RE: Bluewater Mill Site Reclamation Completion Report Comments
License No. SUA-1470, Docket No. 40-8902

Response to NRC's Comments

ADDENDUM 1
RESPONSE TO NRC COMMENTS

Figure 6-1 Area Features and Grid Block Nomenclature for Radiologic

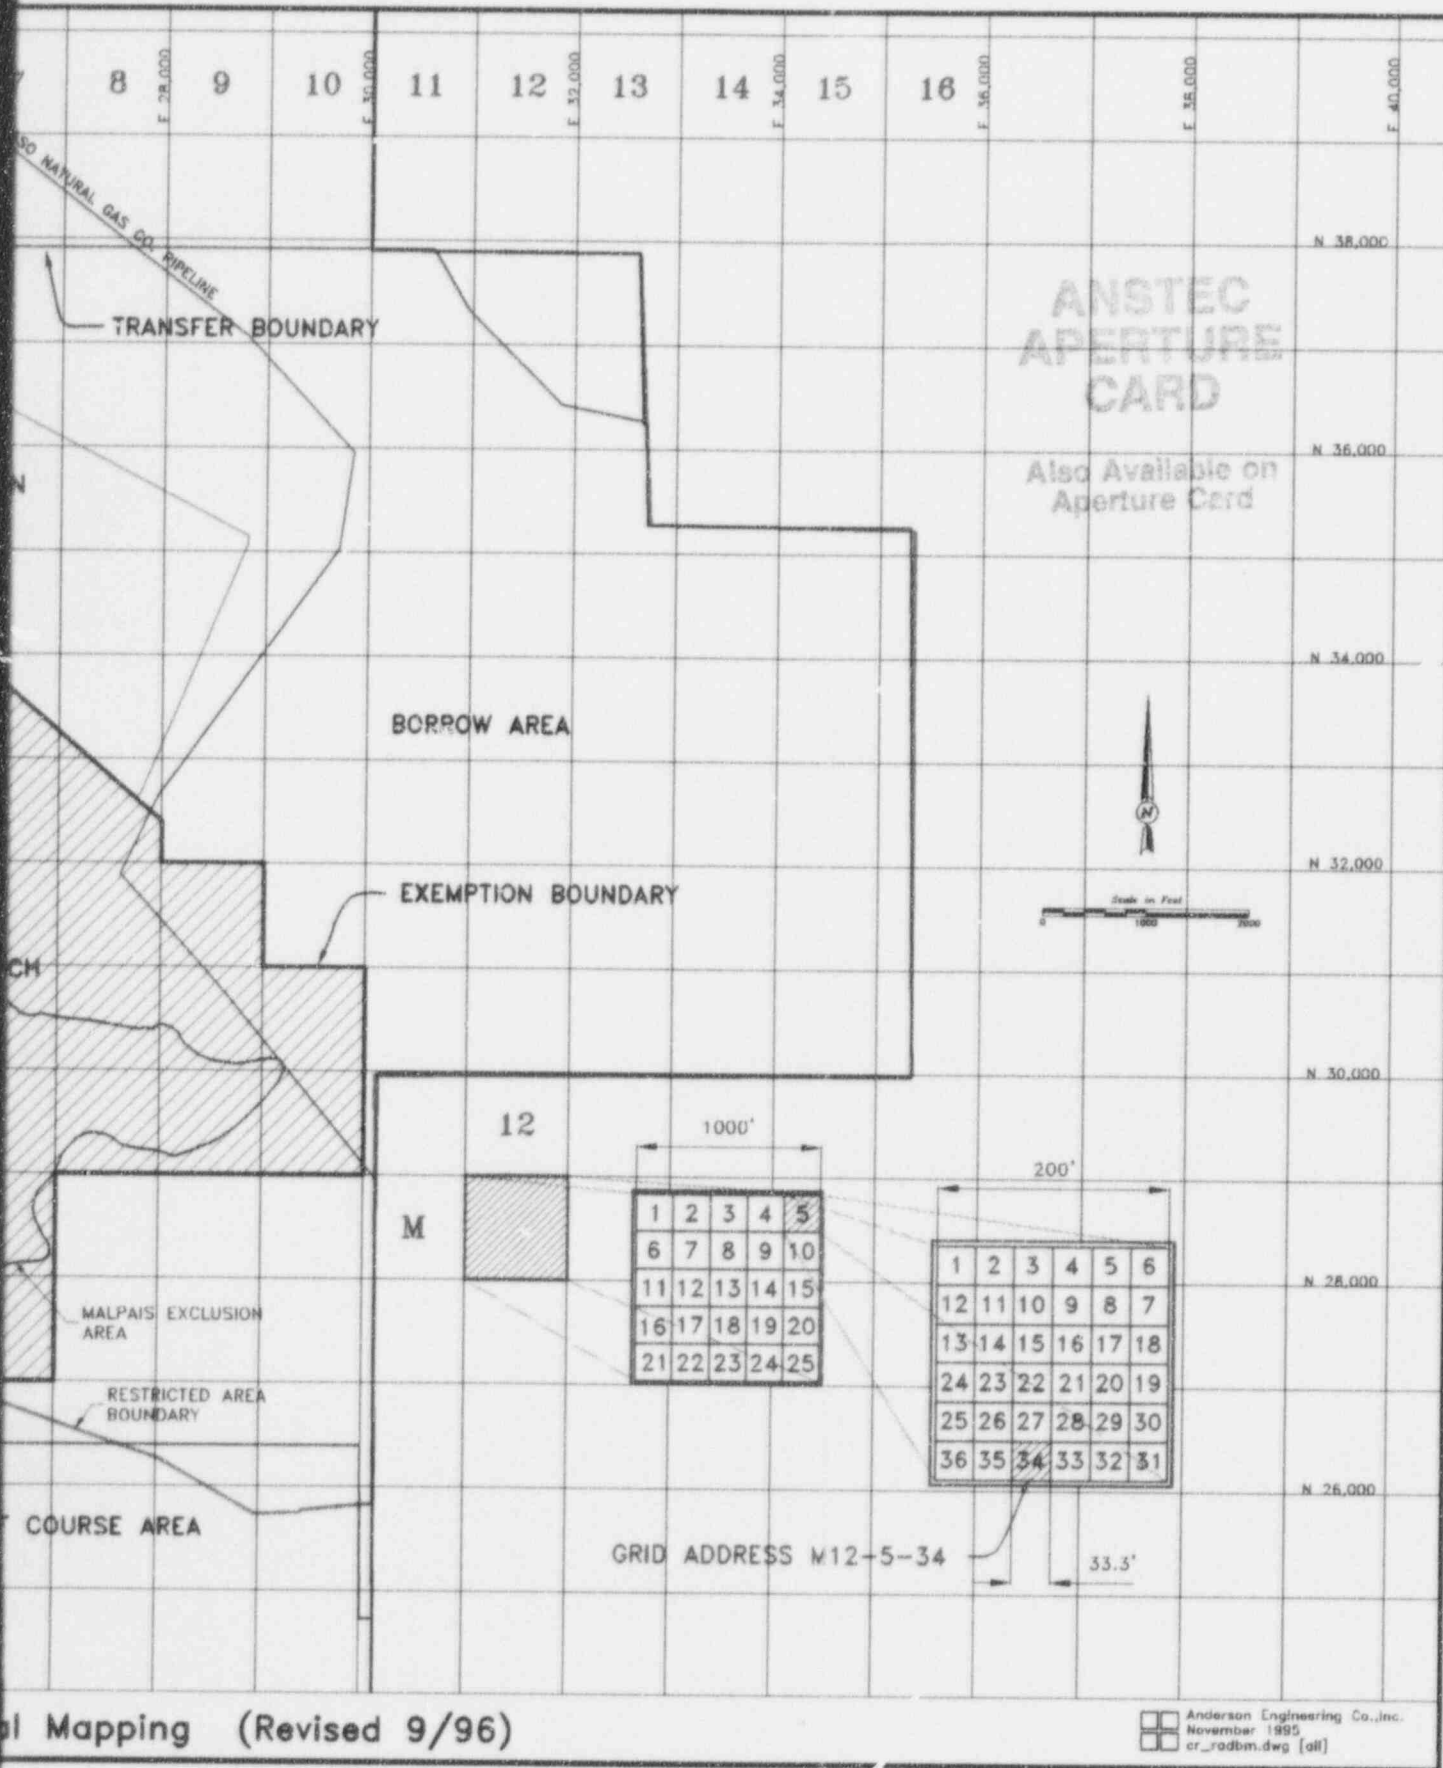
Explain why there are gamma readings where part of the Plant Site Disposal Cell should be (refer to Figure 6-1).

The Site encompasses 5,064 acres, of which 3,761 acres were within the radiological restricted area which is shown in Figure 6-1 included in Attachment 1. Figure 6-1 also shows the Exemption Area and the area to be transfer to the Department of Energy, which are 1,288 and 3,305 acres, respectively.

Figure 6-3 Gamma-Ray Count Rate Measurements North of Exemption

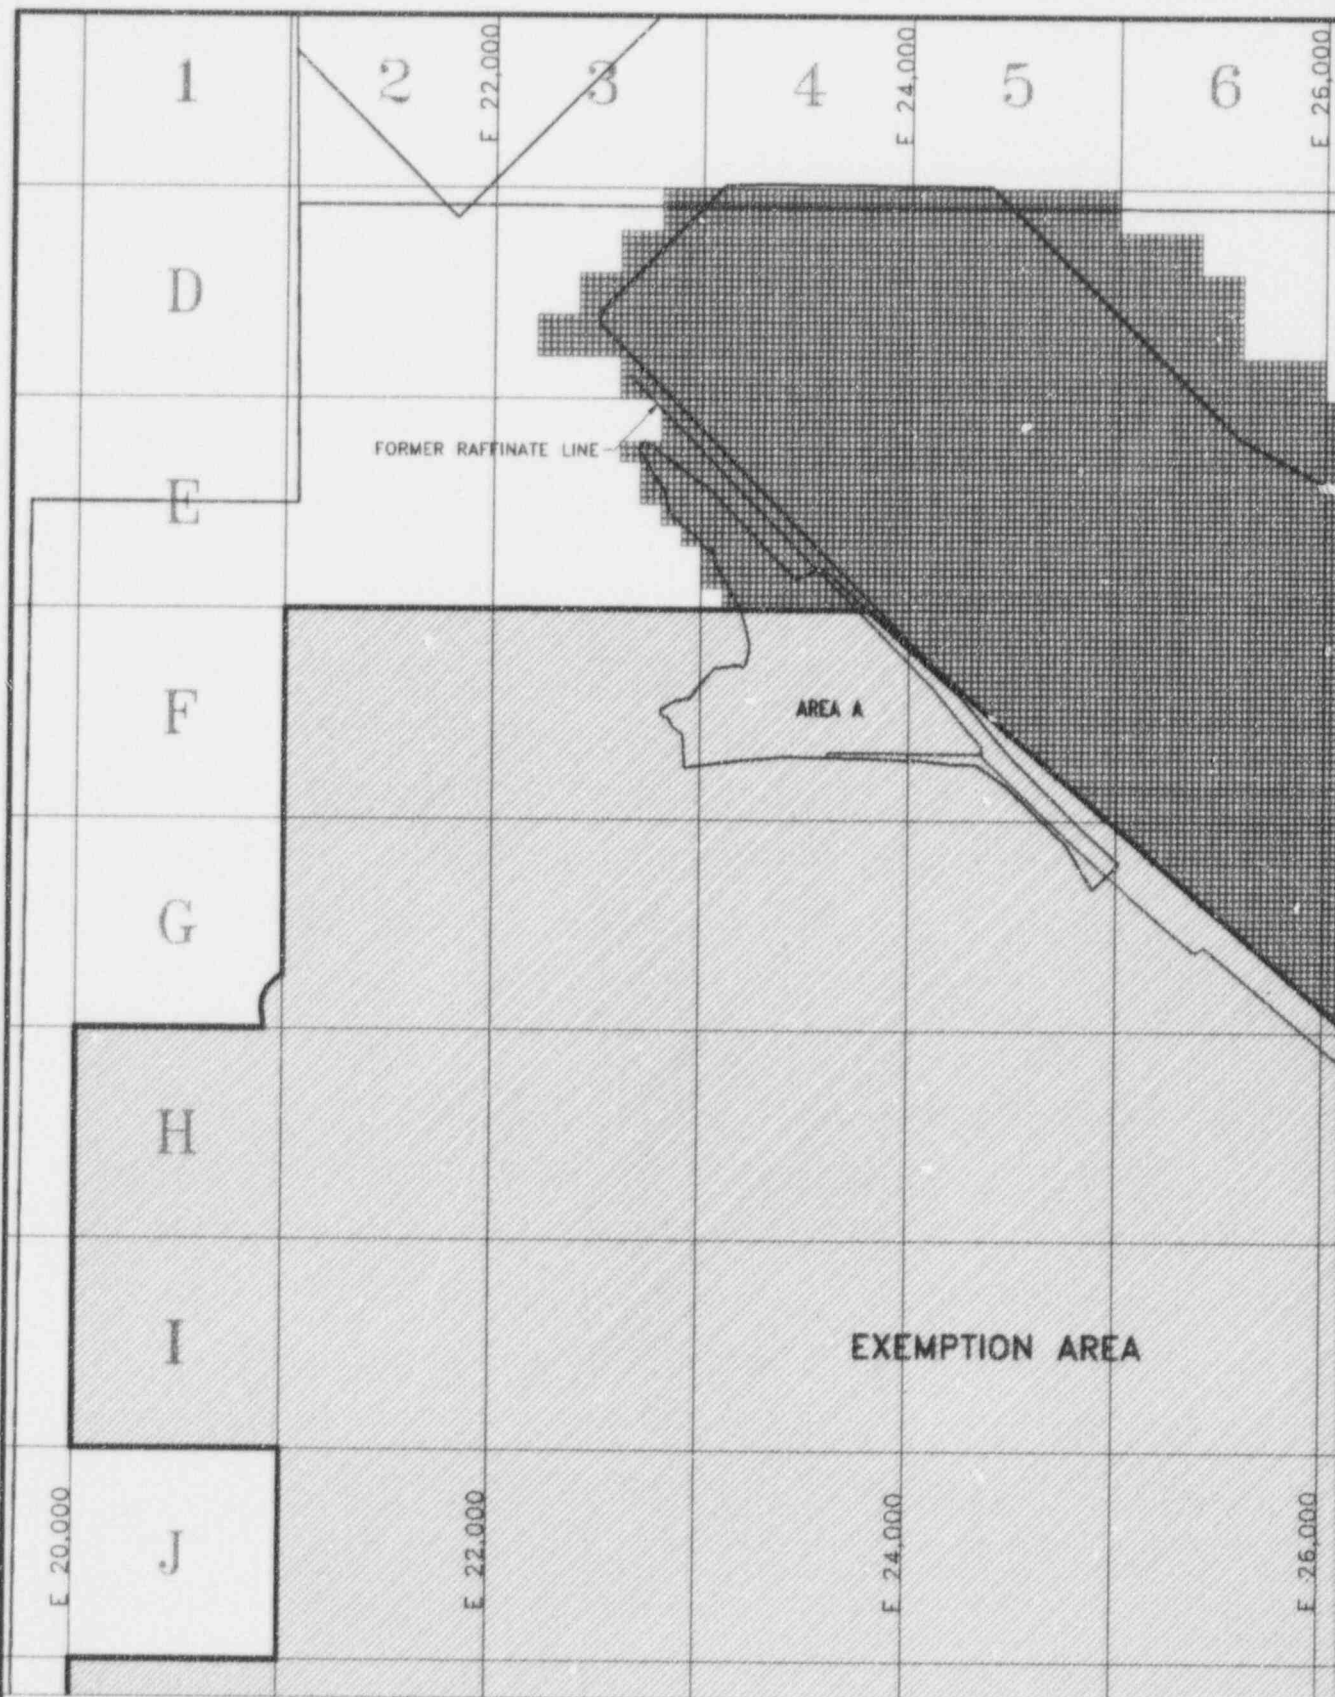
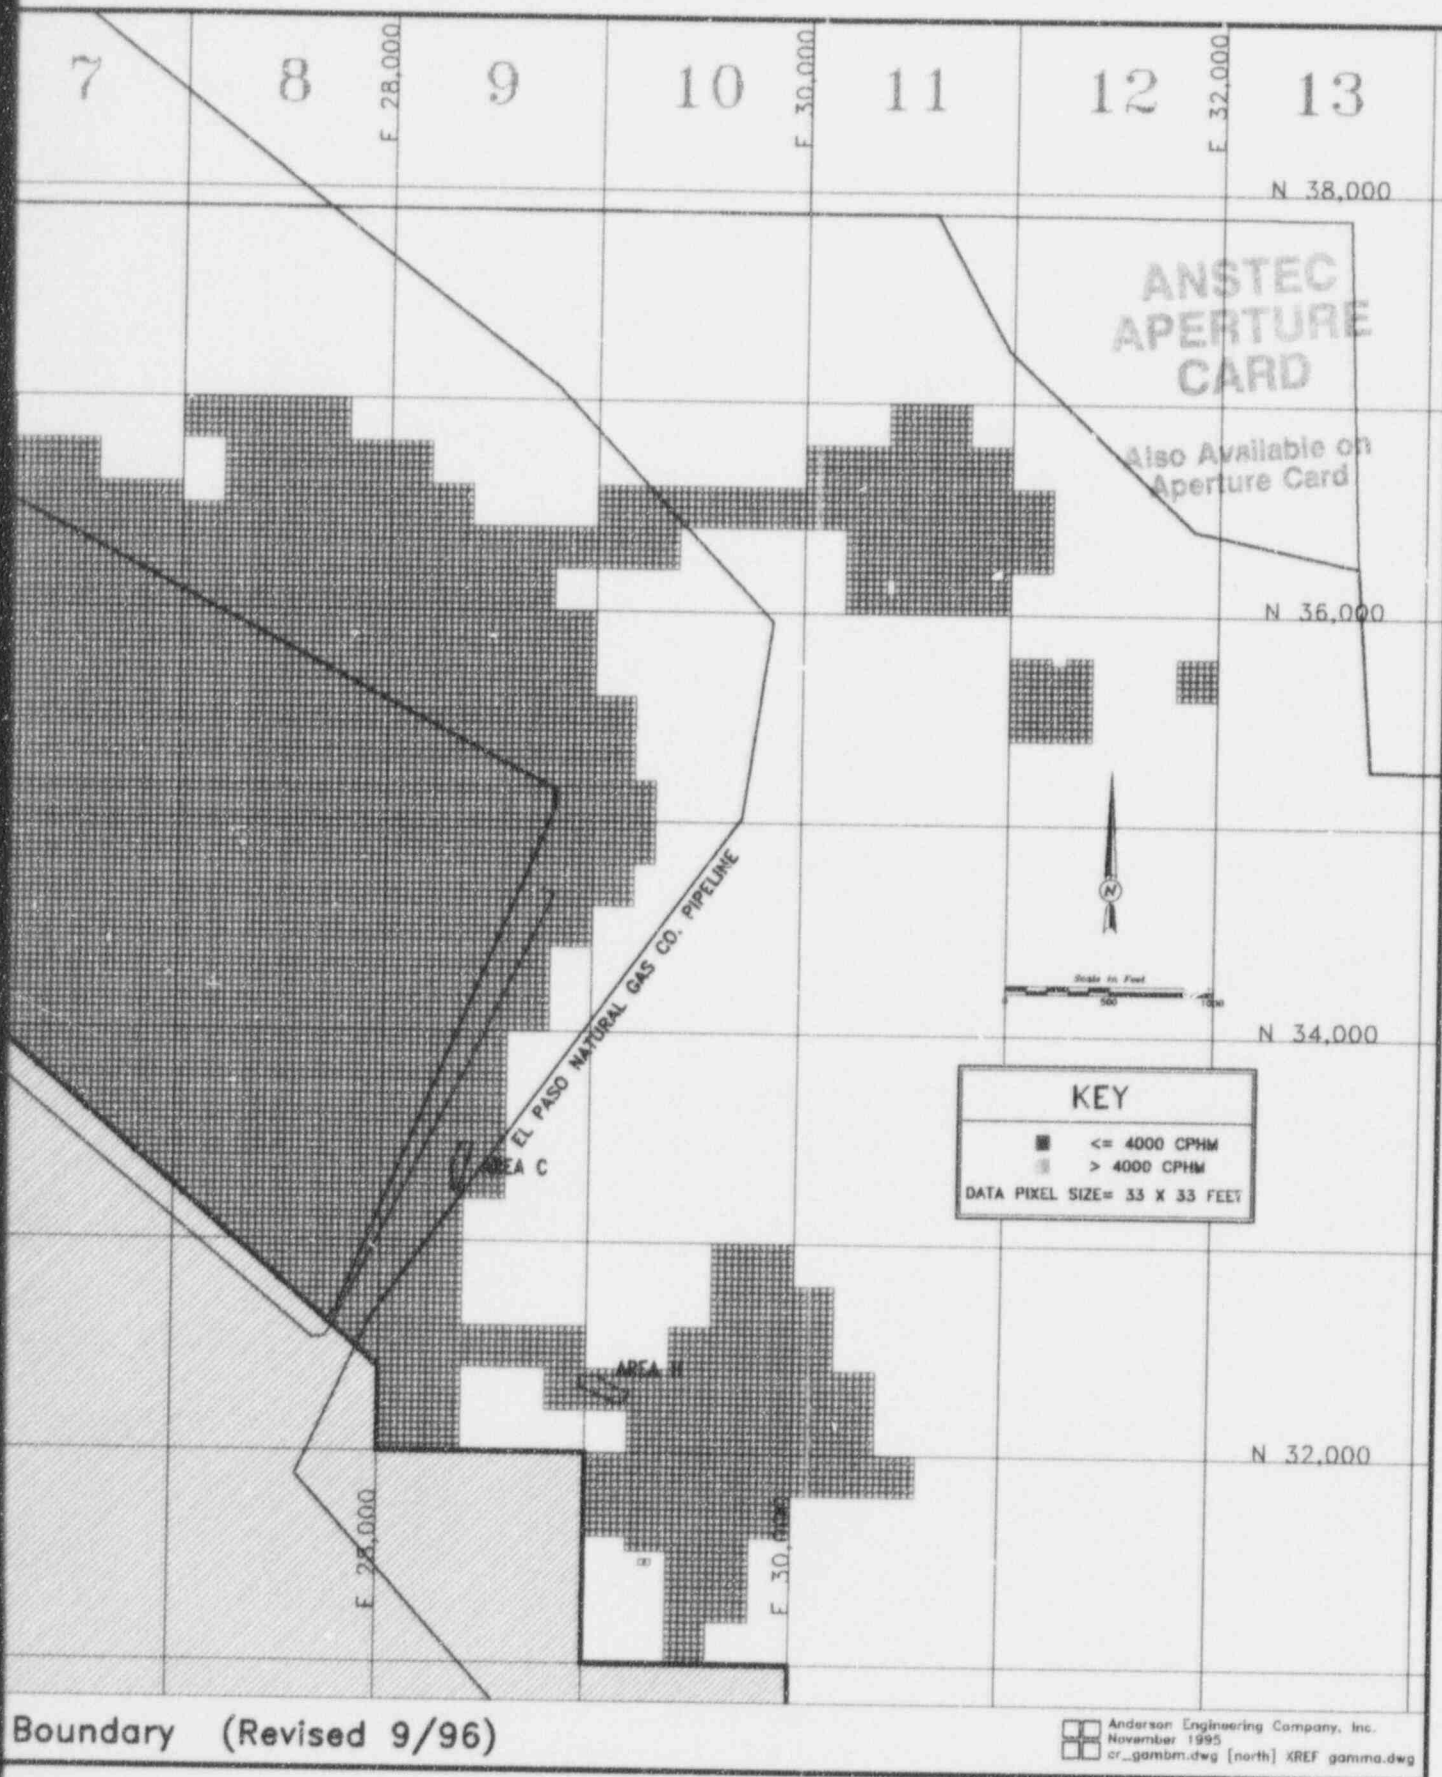
Indicate the location of the verification data for the other 2 areas with anomalous gamma readings (Areas A and C) that was determined to be due to tailings. Area A is not indicated on Figure 6-1 or 6-3, but using the coordinates on map B-3 of the 1992 report, it appears to extend well beyond the exemption area.

As stated in the Windblown Cleanup Report, Area C anomalous gamma readings were due to tailings material from the raffinate line near the eastern edge of the evaporation ponds. The raffinate line was remediated during Phase II reclamation, which followed the windblown cleanup. Revised Figures 6-3 and 6-4, included in Attachment 1, depict Area C and show that Area C meets the cleanup criteria.

As for Area A, additional excavation was conducted after August 1992 utilizing excavation control survey. However, soil sampling verification survey was not conducted because most of the area was located in the Exemption Boundary. The gamma radiation survey and soil sampling were conducted during August 1996 in the portion of Area A which was outside the Exemption boundary. Revised Figures 6-3 and 6-4, included in Attachment 1, depicts Area A, outside the Exemption Boundary, which show that Area A meets the cleanup criteria. Attachment 2 includes soil sampling results for this area in Grid Block E03 and E04.
